# CAPEL MANOR COLLEGE, MOTTINGHAM CAMPUS

Planning Derogation  
January 2024

The document provides a comprehensive synopsis of the changes from the planning approved plan CMC-MOT-L101\_R2 to the current amended plan CMC-PRP-ZZ-00-DR-L-2500\_REVB

## CAMPUS ENTRANCE

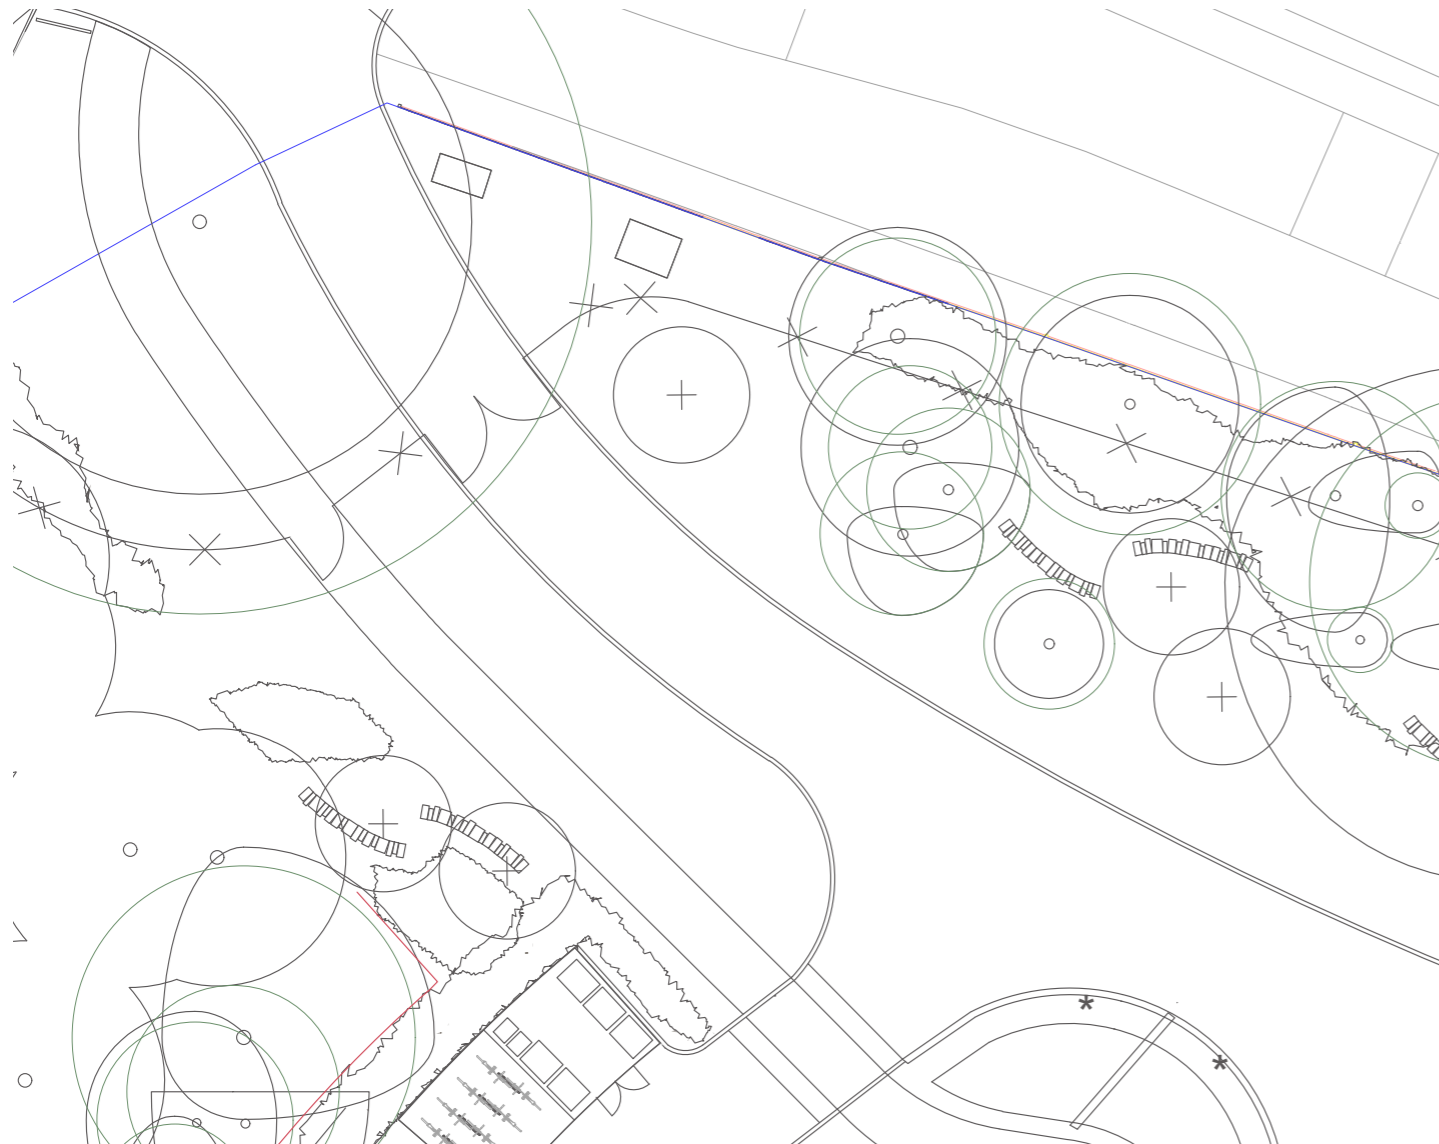
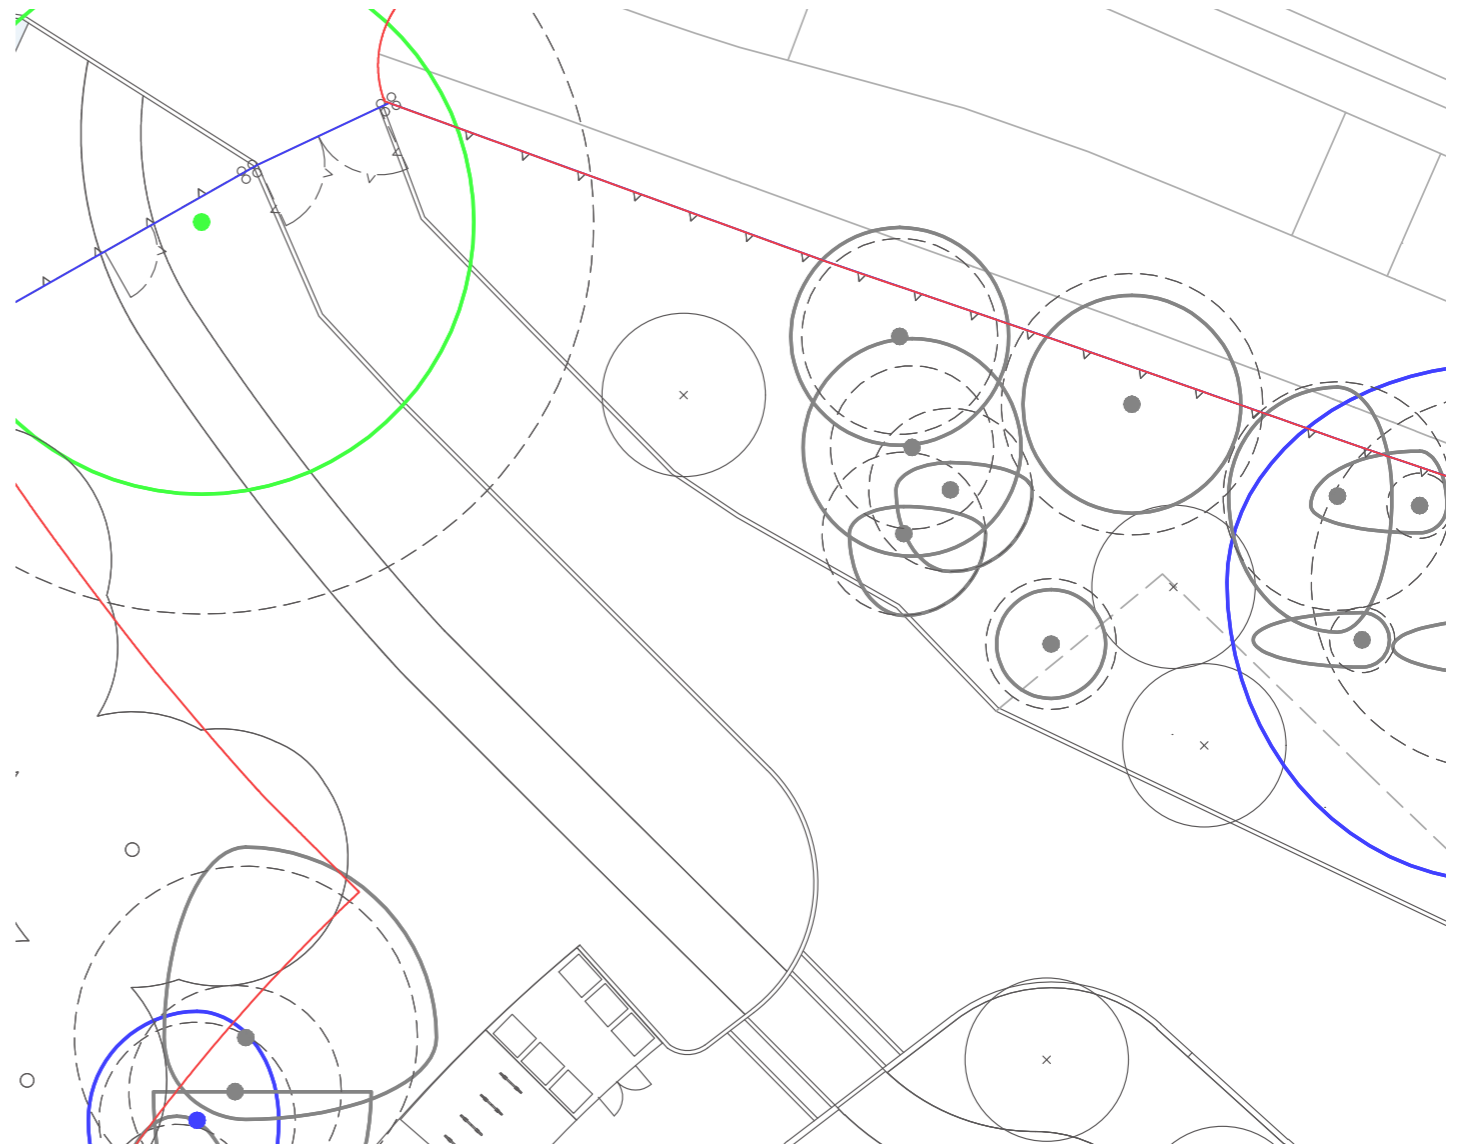
The main changes to the entrance area are the retention of the existing gate and road surfacing, and the omission of proposed trees north of the bin store.

Repainting the gate, with the opportunity for a mural, and making good the hardstanding rather than replacing both, reduces the waste produced on site, and lower the carbon footprint of the overall proposal.

The proposed trees have been removed due to the areas adjacent to the trees as well as opportunities for growth.

## ARRIVAL GARDEN AND PARKING COURT

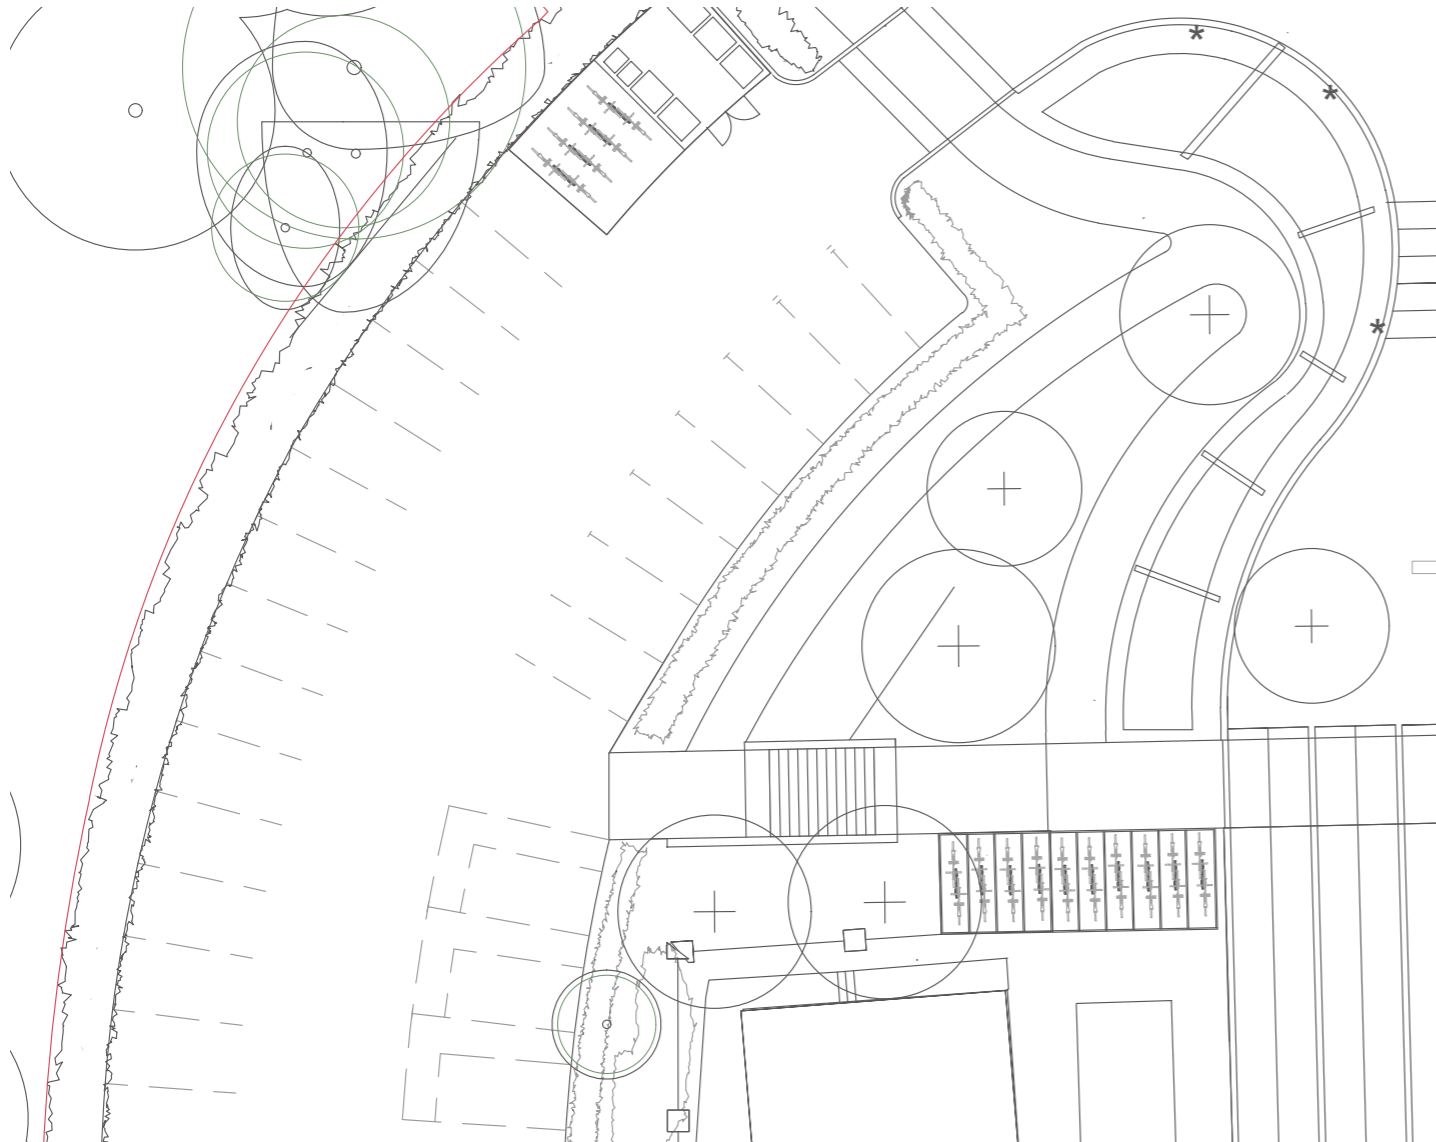
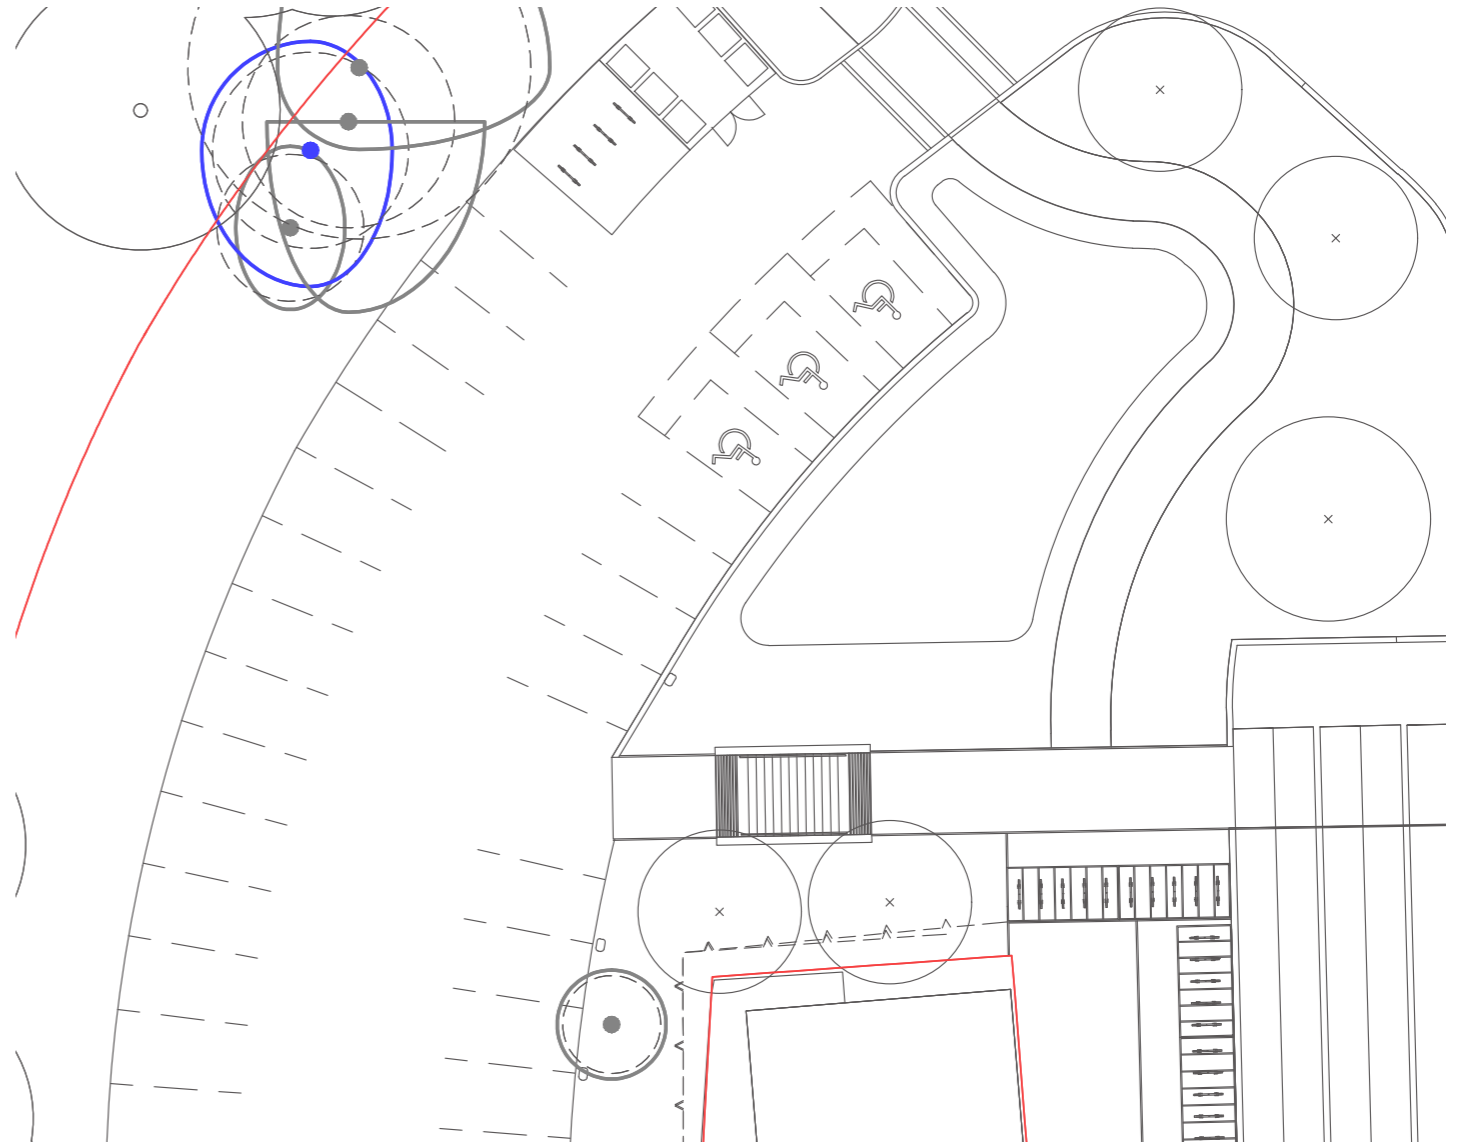
To improve accessibility, the accessible parking bays have been moved closer to the entrance of the parking court. This reduced the travel distance to both the Entrance Square and Welcome Block.

## ENTRANCE SQUARE

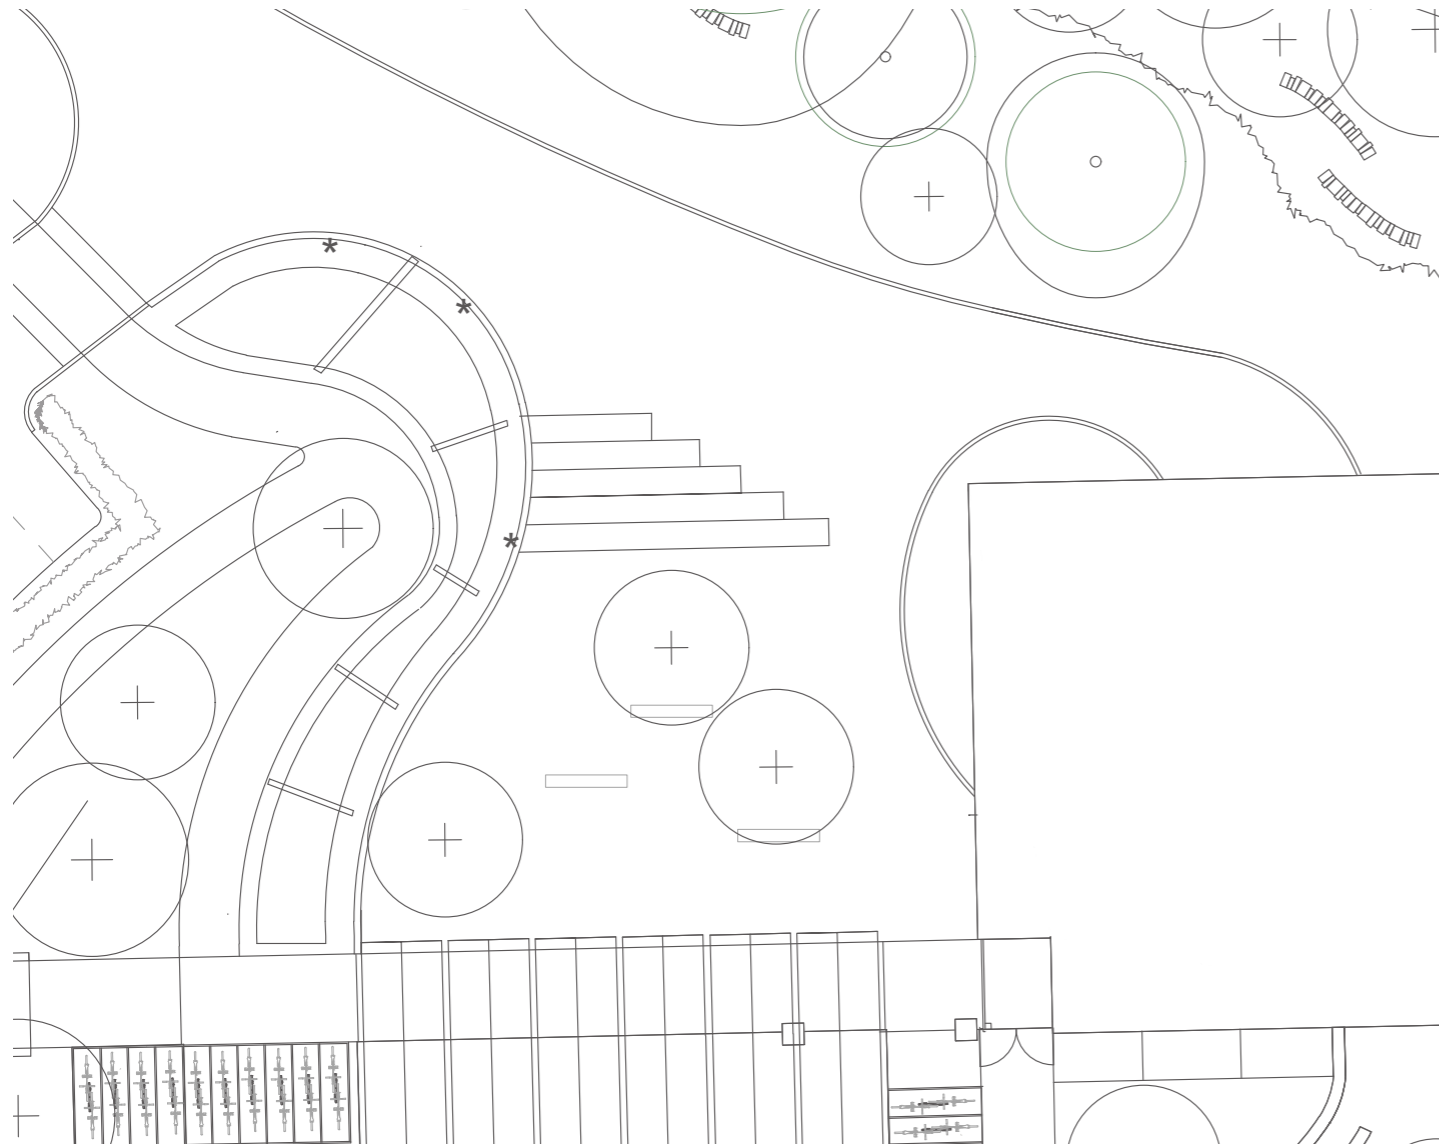
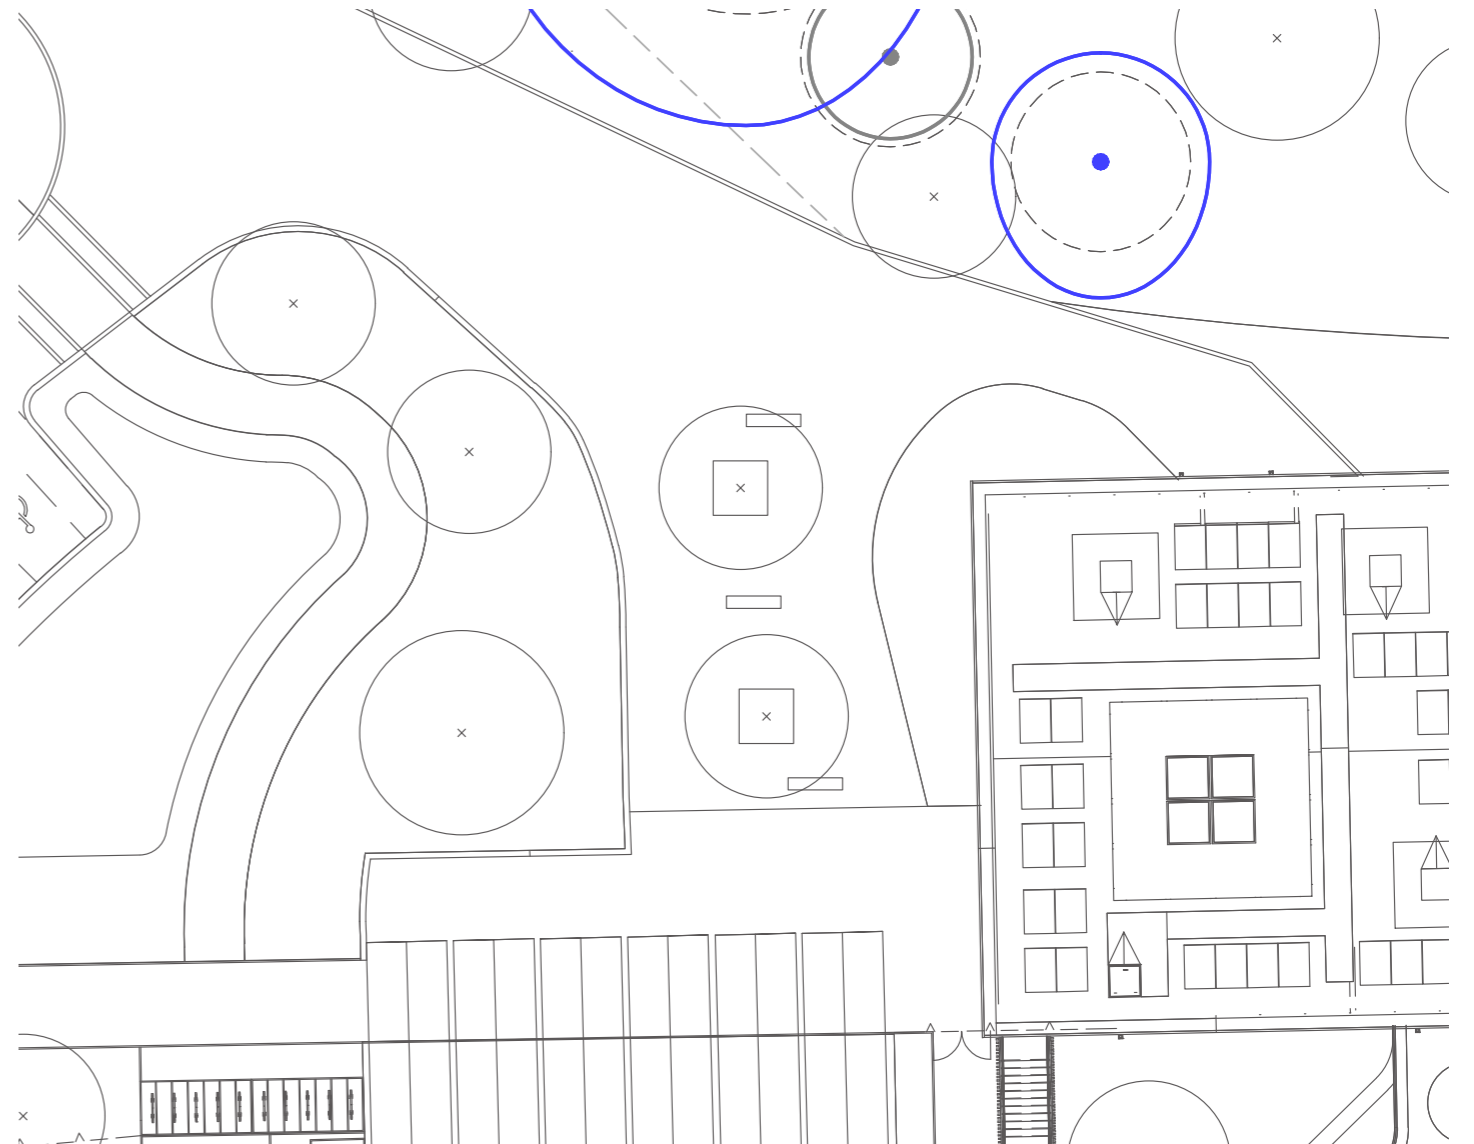
In line with the accessibility improvements of the Arrival Garden, the stramp has been omitted to make the Welcome Terrace fully accessible.

Furthermore, to follow the guiding design principles set out in the DAS, the existing planter wall has been retained and the planting extended to help lower the carbon footprint and provide additional ecological and biodiverse planting communities.
